RAI No.	Section	Issue	Regulatory Link	Discussion	Path Forward
CH-22	Section 7.4 Sensitivity Analysis	Details of Sensitivity Analysis Not Included	10CFR20.2002(d)	Doses of 2.9 mrem for Acute Well-Driller, 3.0 mrem for Chronic Well-Driller, and 16 mrem for the Construction Intruder are provided but the details are not provided in an Attachment. Details are necessary because it is unclear what the concentration and dilution assumptions are for these scenarios.	Please provide the detailed calculations for these doses as were provided for the other scenarios.
<b>Response Summary:</b> Detailed calculations for each of the three scenarios are attached.					
<b>Response Detail:</b> In all cases the bounding concentration was based on 100 percent of the activity being from 3000 pCi/g of total uranium, with the isotopic composition based on existing sample data.

**Overall Comments on Request for Additional Alternate Disposal Approval and Exemptions for Specific Hematite Decommissioning Project Waste at US Ecology Idaho**

Sheet D to Figure 1 to Appendix G of HDP-TBD-WM-906, Sampling Results for the Process Buildings Underground Piping and Site Sewer Lines

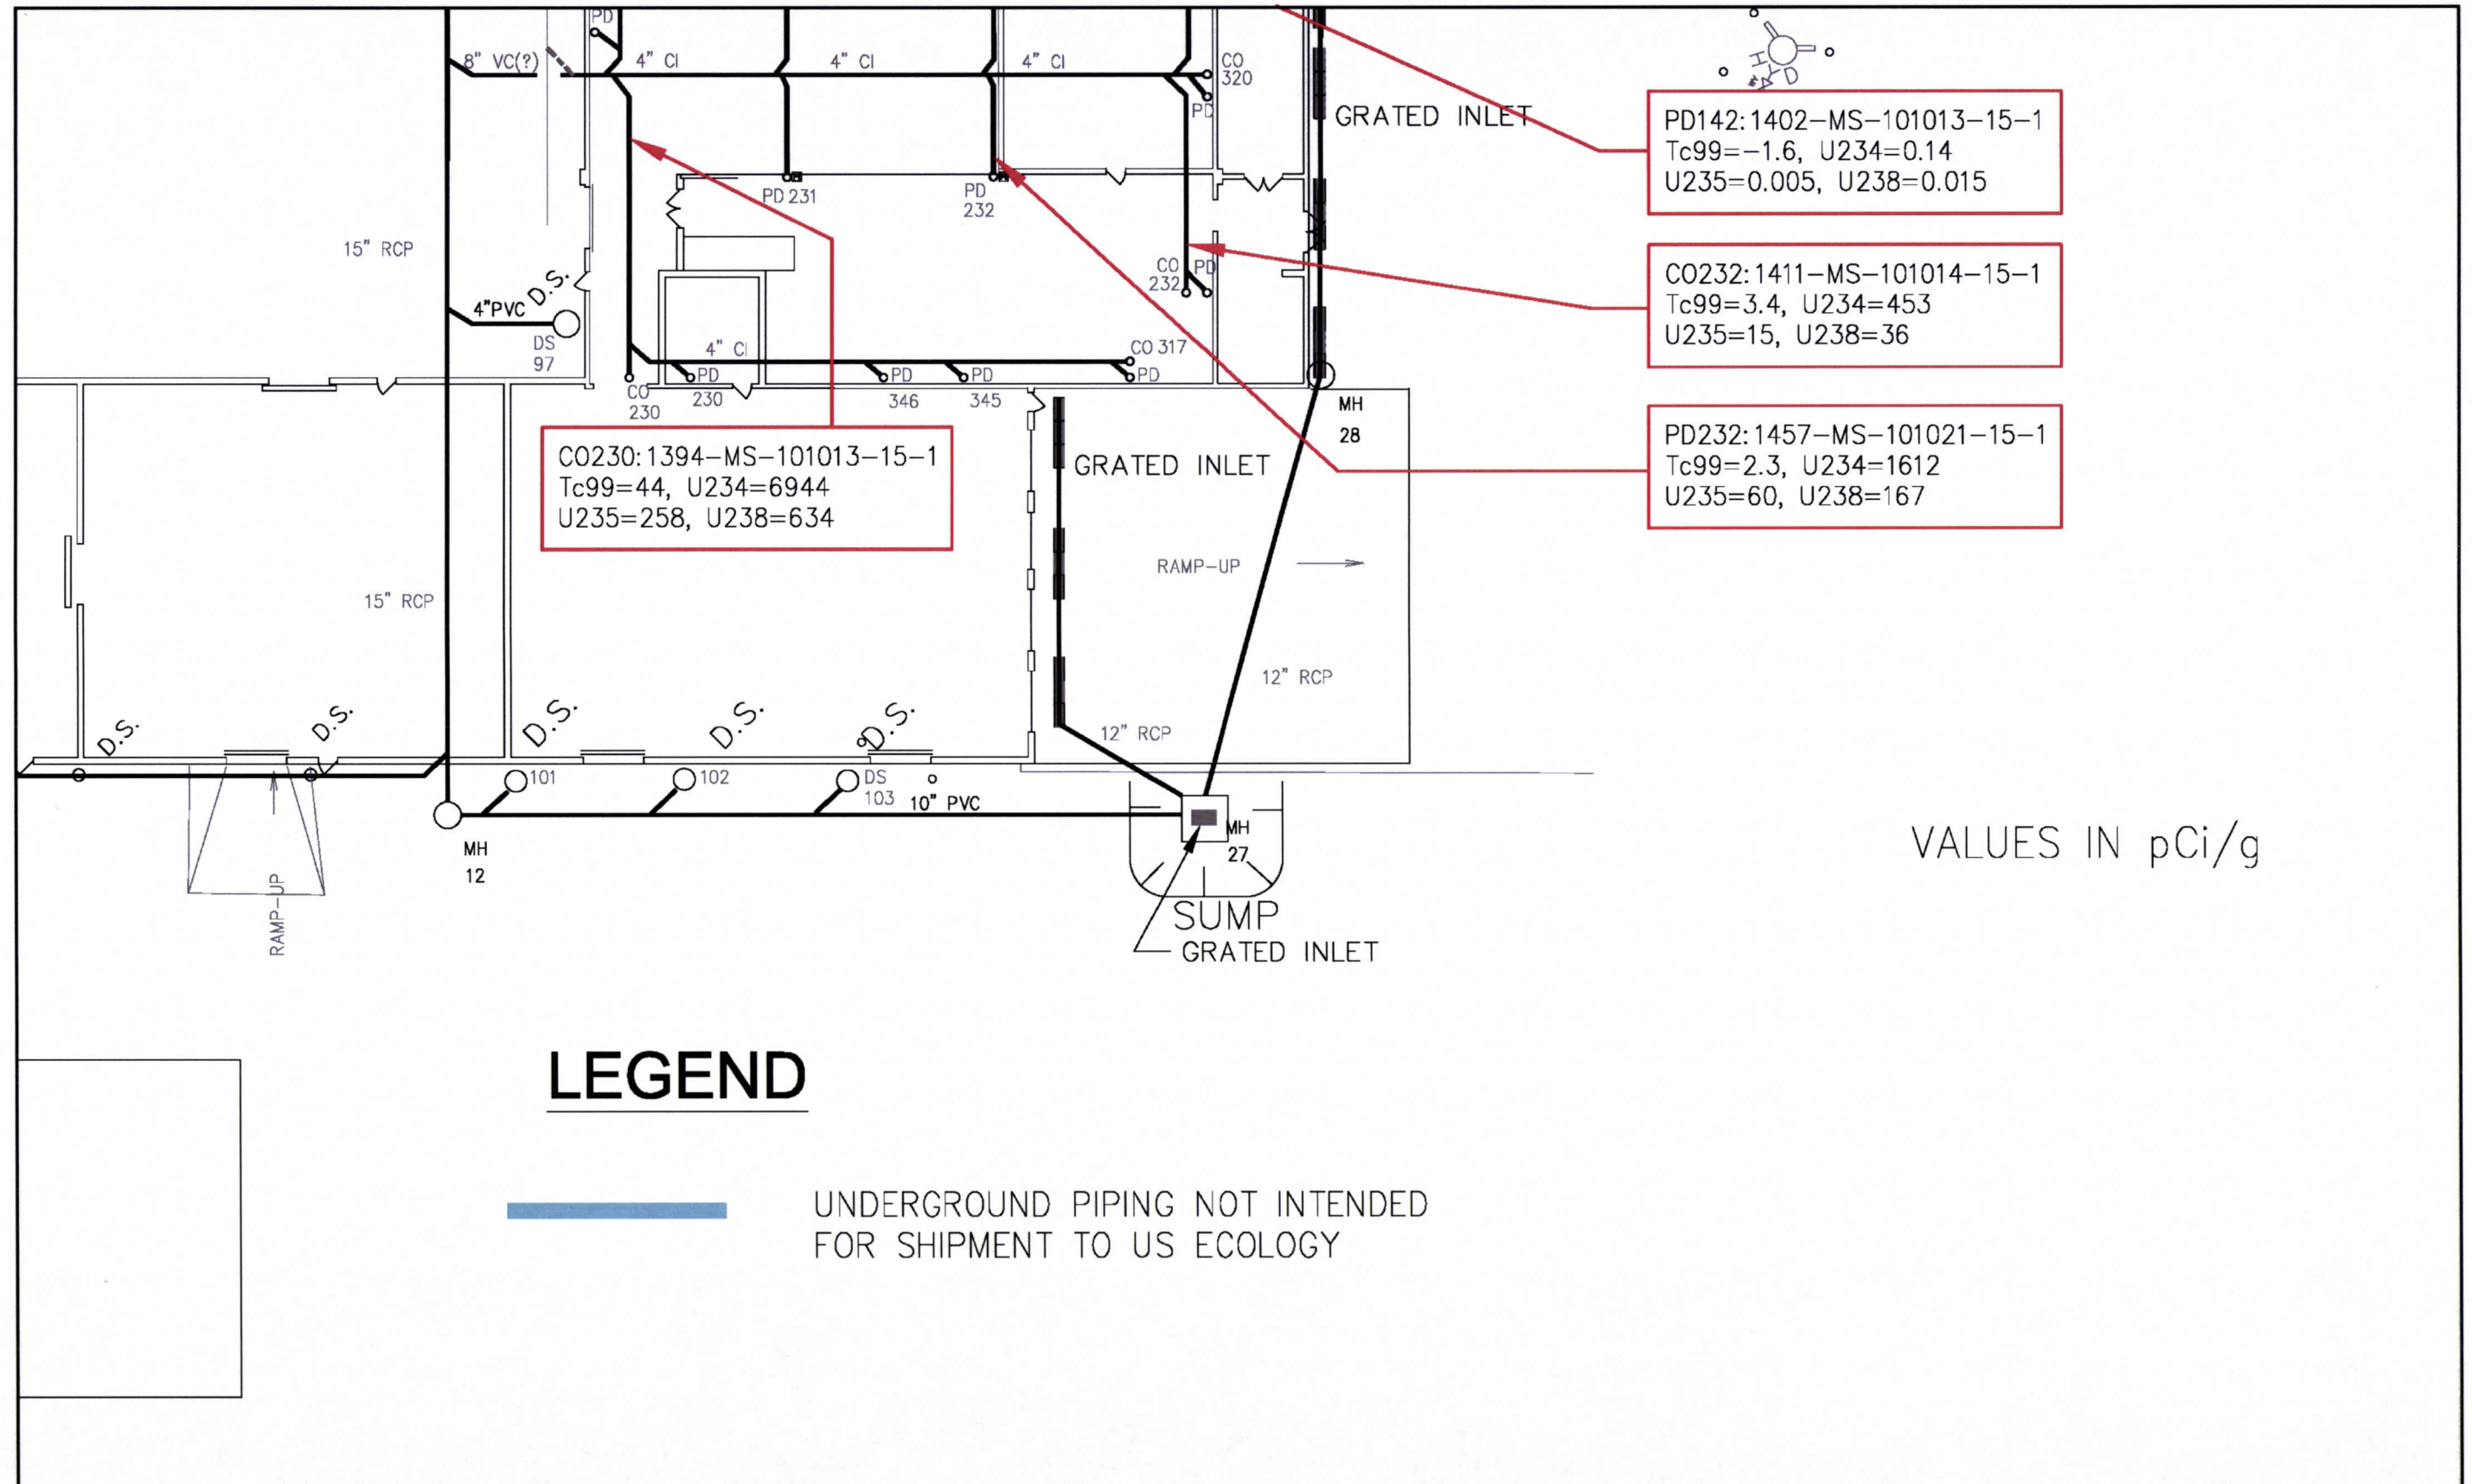
RAI No.	Section	Issue	Regulatory Link	Discussion	Path Forward
SA-7	HDP-TBD-WM-906 Section 7.1 and Appendix G	TBD Section 7.1 and App. G Figure 1 are not descriptive of piping location.	10CFR20.2002(a)	The link between piping to area and building populations is unclear.	Provide additional graphics or tables to clearly segregate piping and identify the location.
<b>Response Summary:</b> Additional graphics are provided to provide visual reference between					
<b>Response Detail:</b> Appendix F contains the specific piping included in each of the piping group designation (such as “Building 240 Middle System”) identified in Tables 7-4 and 7-5 of Section 7.1 of HDP-TBD-WM-906. In Appendix F of HDP-TBD-WM-906, the ‘From’ and ‘To/Toward’ columns contain identifiers that can be located on Figure 1 of Appendix G to HDP-TBD-WM-906 for the piping groups identified in Tables 7-4 and 7-5 of Section 7.1 of HDP-TBD-WM-906. Figure 1 to Appendix G has been broken into quadrants to facilitate it use, as provided below. A number on the figure without an associated alpha character (e.g., 203) should be read as being associated with ‘FD’ (e.g., FD 203). In some the entire words may be spelled out instead of just the alpha character (e.g., ‘204 Storm Drain’ instead of ‘SD 204’).

RAI No.	Section	Issue	Regulatory Link	Discussion	Path Forward
ENCL-5	Section 5.1	Criticality Safety Assessment, FNMCP & Physical Security	10CFR74.11	It is stated that the waste in the soil, slabs, concrete, asphalt, or HVAC equipment would consist of U-235 at enrichment levels averaging below 10%.	Provide the basis for concluding that there will be any U-235 in the soil, slabs, concrete, asphalt, or HVAC equipment enriched to levels above 5%.
<b>Response Summary:</b> Existing characterization data has identified					
<b>Response Detail:</b> Table 4-1 from HDP-TBD-WM-906 provides a summary of the average enrichment measured for each waste stream component. These range from 3.4 to 5 percent. While this represents the average enrichment, there are individual samples that indicate the presence of materials with a higher enrichment. For example, four concrete samples (1, 2B, 13 and 14) have enrichments exceeding 5 percent (8.2, 18.7, 9.4 and 15.6 percent), as listed in Table 1-2 of NSA-TR-HDP-11-11 (Attachment 10 to HEM-12-2). Other examples are internal pipe sample results listed in the figure associated with RAI SA-7 above.
